Issue	**1**
Factory ID	**25334**
Date of Issue	**22-Apr-2026**

First American Corporation (Pvt.) Ltd.

Structural Safety Inspection Report

Pakistan Accord Initial Safety Inspection Report

Figure 2.1 - Location of OHWT at the Third Floor of Garment Building

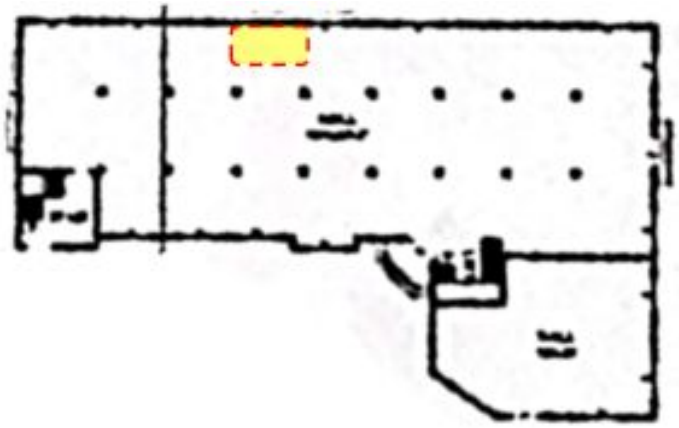
This issue refers to the third floor of the Garment Building, where the Overhead Water Tank (OHWT) is located. Cracks have been observed in the RC retaining walls of the tank and the supporting beams and columns. The reinforcement is severely corroded and exposed due to concrete spalling at several locations. This condition may reduce the structural capacity of the tank and its supporting elements. The deterioration may also be associated with moisture ingress from the tank, which can accelerate corrosion in the supporting structural components beneath the floor. F-202603-064366

Timeline	Remediation Plan
Medium Term CAP-0075842	Identify the cause of the damage / source of water ingress and propose measures to prevent further water damage .
Medium Term CAP-0075843	Inspect damage to the RC walls, beams and columns and propose repairs to structure.
Medium Term CAP-0075844	Submit report capturing above to Pakistan Accord for review.
Longer Term CAP-0075845	Implement the required remedial works.
Longer Term CAP-0075846	Continue to monitor for future signs of water ingress/damage.

Figure 2.5 - Location of Missing Bracing at the Second Floor of Belt Stitching and Packing Department Building

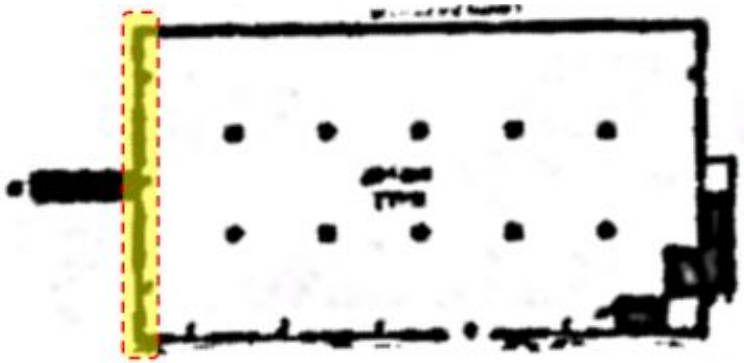
This issue refers to the Second Floor of the Belt Stitching and Packing Department Building. The vertical cross bracing appears to be missing due to the presence of a door opening, which may compromise the lateral load resistance and overall structural stability of the steel shed. As the structural design documentation for the shed is not available, the adequacy of the existing lateral stability system cannot be verified. F-202603-064367

Timeline	Remediation Plan
Medium Term CAP-0075849	Building structural engineer to review the as-built design for code compliance (vertical and lateral loads) and confirm if it is adequate.
Medium Term CAP-0075850	Propose strengthening works as required and submit to Pakistan Accord for review.
Longer Term CAP-0075851	Implement strengthening works as required.

Figure 2.15 - Red Line Indicated Missing Edge Protection Boundary at the Roof of Admin Block

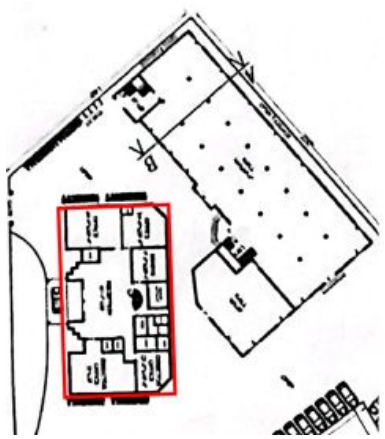
It concerns with inadequate edge protection at the roof of the Admin Block which present a risk of potential injury resulting from slip, trip or fall from roof during the access and maintenance of services – Health & Safety concern. F-202603-064369

Timeline	Remediation Plan
Immediate CAP-0075878	Provide adequate edge protection on the roof, and on any other part of the factory with the same issue.

Figure 2.17 - Red Line Indicated Missing Edge Protection Boundary at the Roof of Heat Transfer and Bag Production Building

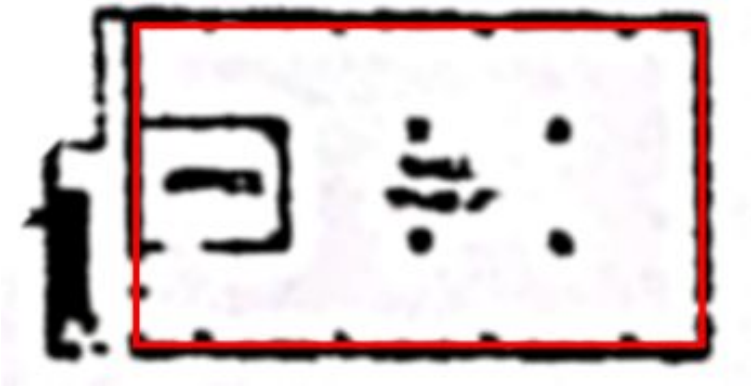
It concerns with inadequate edge protection at the roof of the Heat Transfer / Bag Production Building which present a risk of potential injury resulting from slip, trip or fall from roof during the access and maintenance of services – Health & Safety concern. F-202603-064375

Timeline	Remediation Plan
Immediate CAP-0075879	Provide adequate edge protection on the roof, and on any other part of the factory with the same issue.

Figure 2.27 - Location of Steel Staircase in the Hummel Building

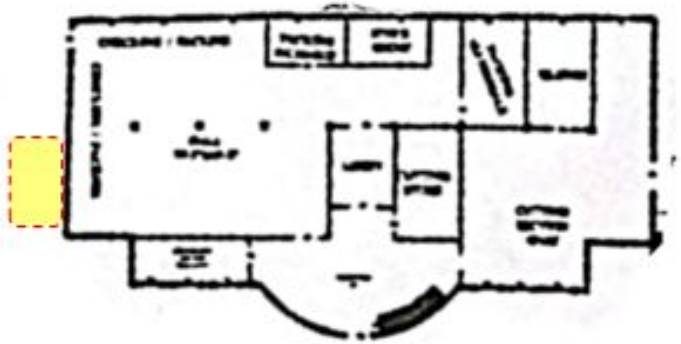
This issue refers to the steel stairs in the Hummel Building. The stairs have undersized structural elements and lack proper bracing, making them highly vulnerable. F-202603-064373

Timeline	Remediation Plan
Medium Term CAP-0075891	Building structural engineer to review the as-built design for code compliance (vertical and lateral loads) and confirm if it is adequate.
Medium Term CAP-0075892	Propose strengthening works as required and submit to Pakistan Accord for review.
Longer Term CAP-0075893	Implement strengthening works as required.
